**MONTGOMERY COUNTY HISTORIC PRESERVATION COMMISSION**  
**STAFF REPORT**

<b>Address:</b>	13 East Melrose Street, Chevy Chase	<b>Meeting Date:</b>	2/26/2020
<b>Resource:</b>	Contributing Resource Chevy Chase Village Historic District	<b>Report Date:</b>	2/19/2020
<b>Applicant:</b>	Thomas O'Donnell and Caroline Fawcett (Vince Greene, Architect)	<b>Public Notice:</b>	2/12/2020
<b>Review:</b>	HAWP	<b>Tax Credit:</b>	n/a
<b>Case Number:</b>	35/13-20F	<b>Staff:</b>	Dan Bruechert
<b>Proposal:</b>	Fenestration Alteration

PROJECT NAME:	DRAWING TITLE:	© 2019 GREENARCH	DATE:	DRAWING #:
FAWCETT/O'DONNELL RESIDENCE 13 E. MELROSE STREET CHEVY CHASE, MARYLAND 20815	EXISTING/PROPOSED REAR ELEVATION (NORTH)	SCALE: 1/8" = 1'-0"	CREATED: 01/16/2019	A-201  21
			REVISED: 03/06/2019	
			HPC 2: 01/22/2020

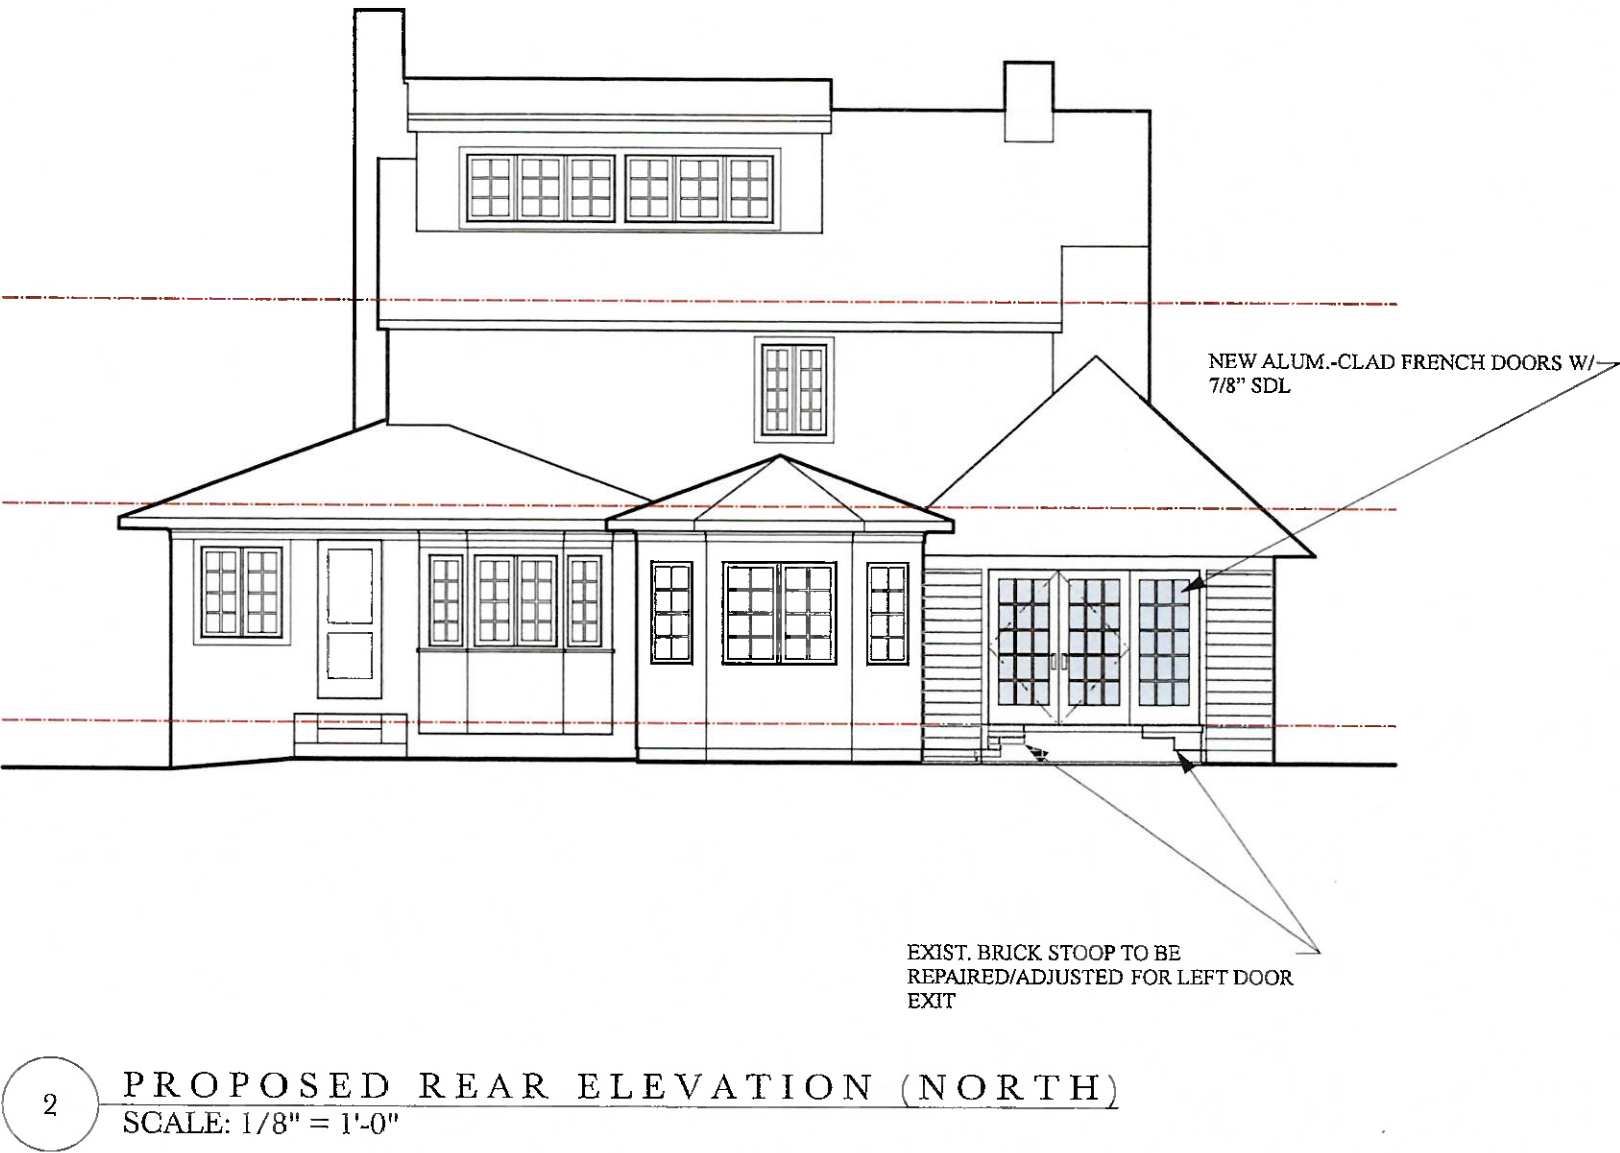
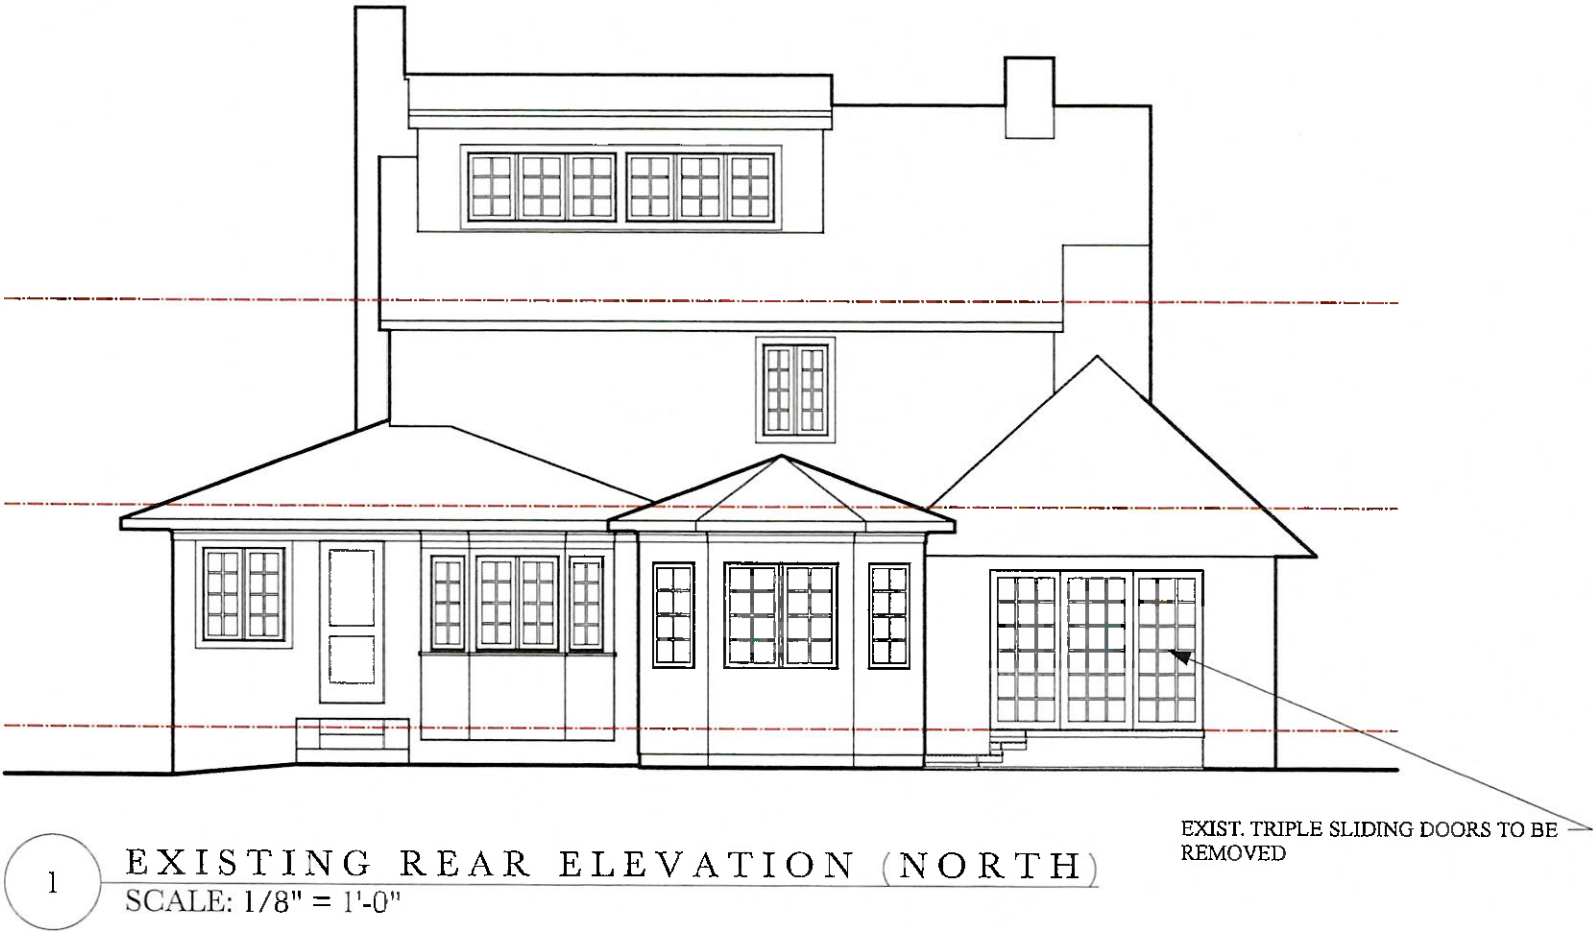
In the northwest corner of the house, there is a set of triple aluminum sliding glass doors. These doors are

not historic and are not visible from the surrounding district. Staff supports the removal of this feature.

In place of the existing door, the applicant proposes installing a pair of Pella Architect Series French doors with a matching fixed panel in the same location. As this is not a historic feature and is not visible from the public right-of-way, the *Design Guidelines* state review of this element should be subject to very lenient scrutiny. Under this level of review, Staff finds the proposed change is appropriate and recommends approval of the door replacement.

PROJECT NAME:	DRAWING TITLE:	© 2019 GREENEARCH	DATE:	DRAWING #:
FAWCETT/O'DONNELL RESIDENCE 13 E. MELROSE STREET CHEVY CHASE, MARYLAND 20815	EXISTING/PROPOSED SIDE ELEVATION (WEST)	SCALE: 1/8" = 1'-0"	CREATED: 01/16/2019	A-202  22
			REVISED: 03/06/2019	
			HPC 2: 01/22/2020

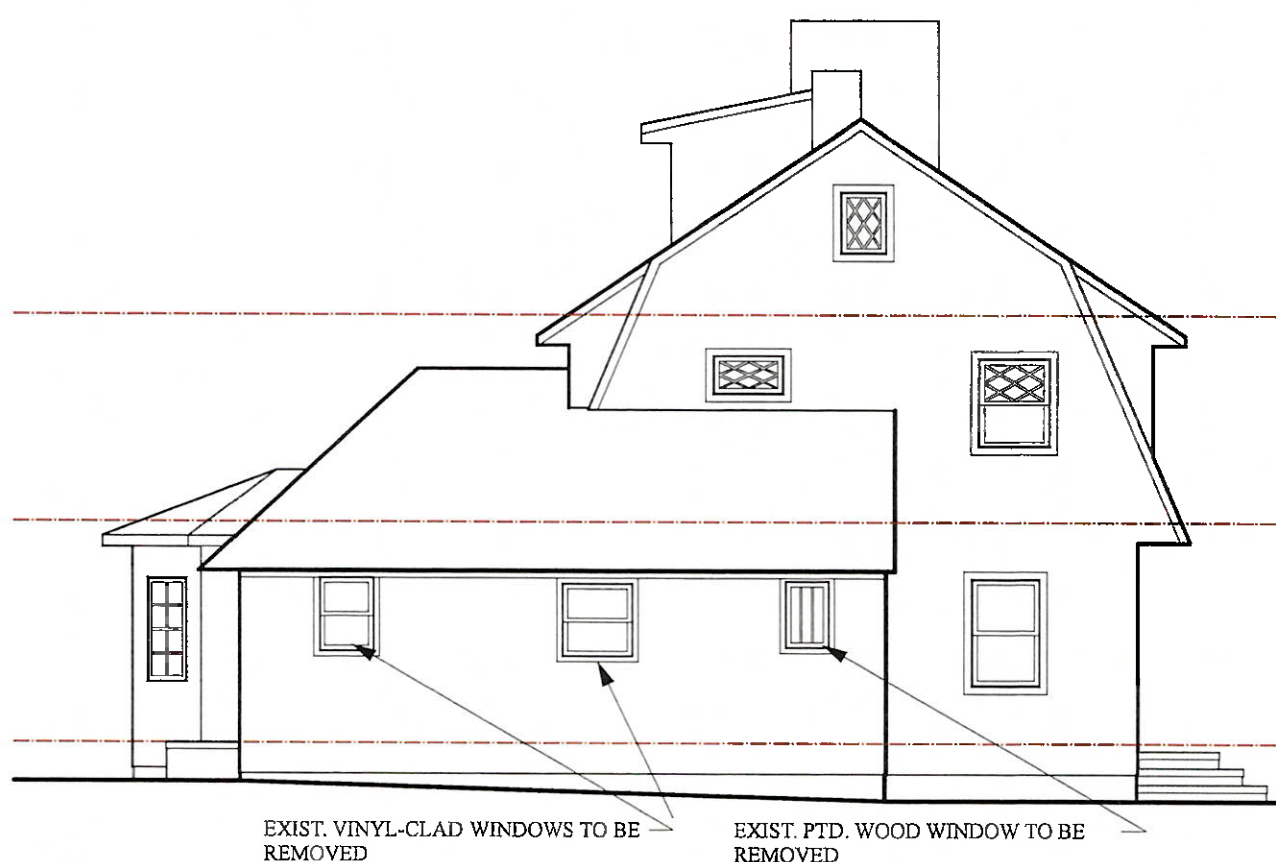
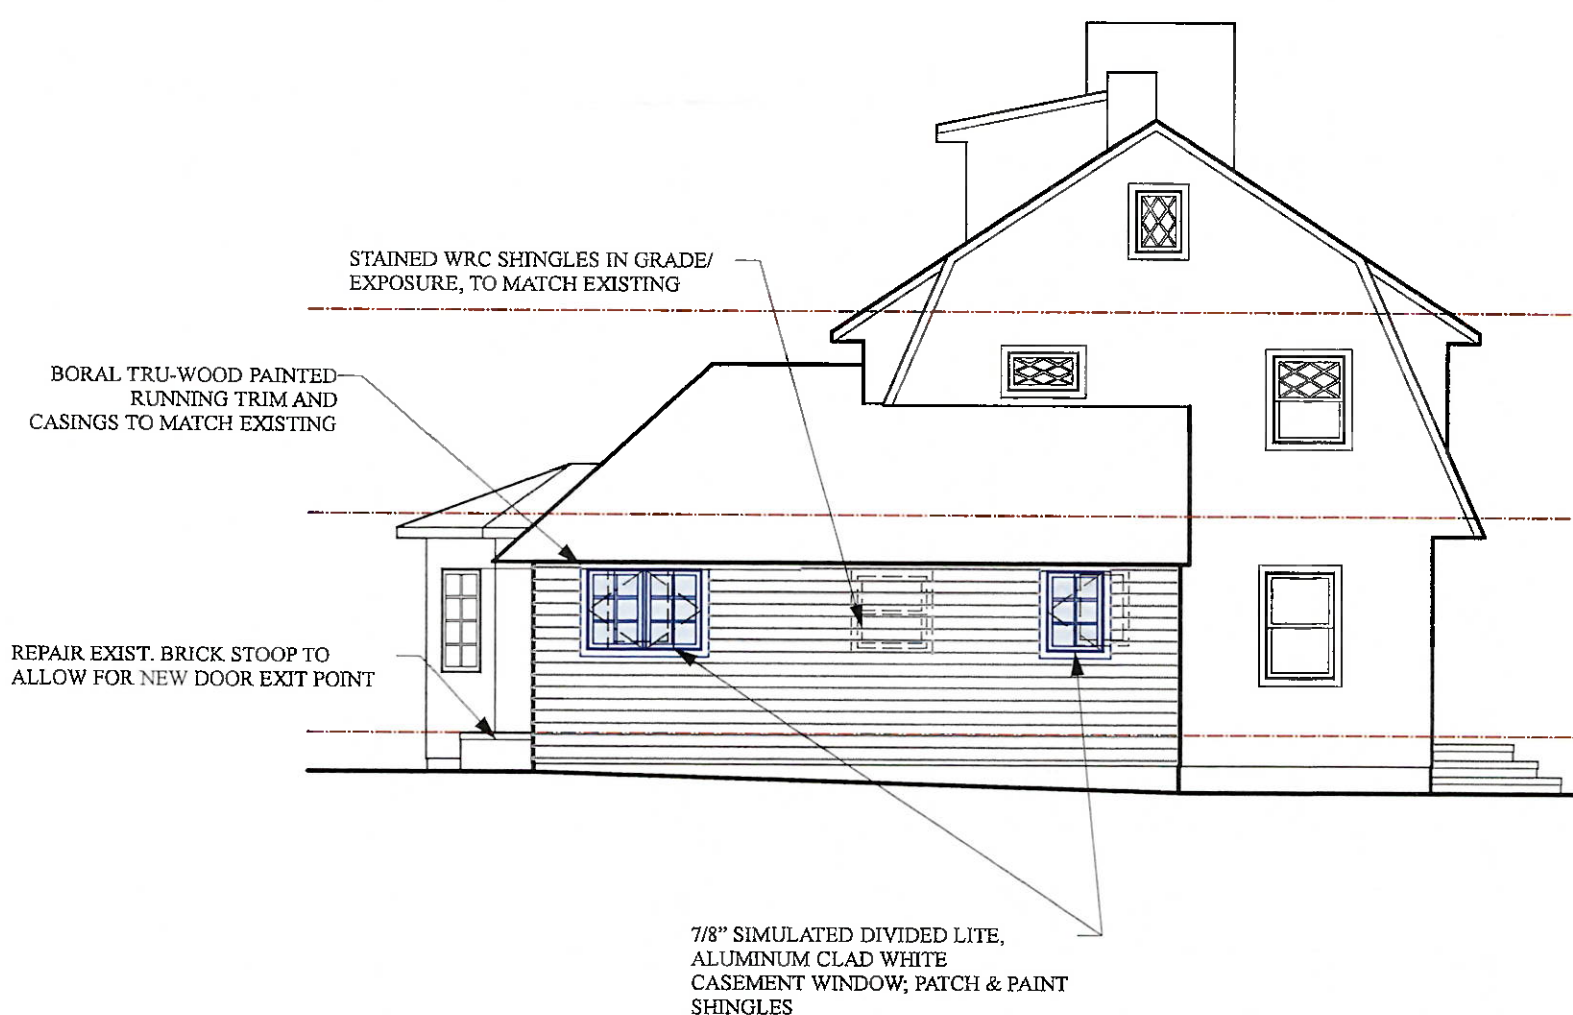
On the first floor of the west elevation, there are three windows, two vinyl clad windows to the rear and one wood casement window toward the front of the house. The applicant proposes removing all three of these windows. Staff finds that these windows are not historic and their removal will not result in a loss of integrity.

The applicant proposes changing the window placement on this elevation. In place of the existing wood casement window, the applicant proposes installing a new, six lite aluminum-clad wood casement window. The central vinyl window opening will be covered in new shingles to match the existing siding, and the rearmost window opening will be expanded to accommodate a paired set of six lite aluminum-clad wood casement windows.

Staff finds that while this section of the house shows up on the 1927 Sanborn Map, the current appearance is not historic. This is evident from the materials used and the configuration of the existing windows. The front and side of the house have a combination of casement and sash windows with a diamond pattern. The windows on the rear and non-historic additions use multi-lite casement windows. Staff finds that the proposed six-lite aluminum-clad wood casement windows are consistent with the windows on the side and rear of the house and are compatible with the design and materials utilized in the non-historic sections of the house. Staff recommends approval of the window replacement.
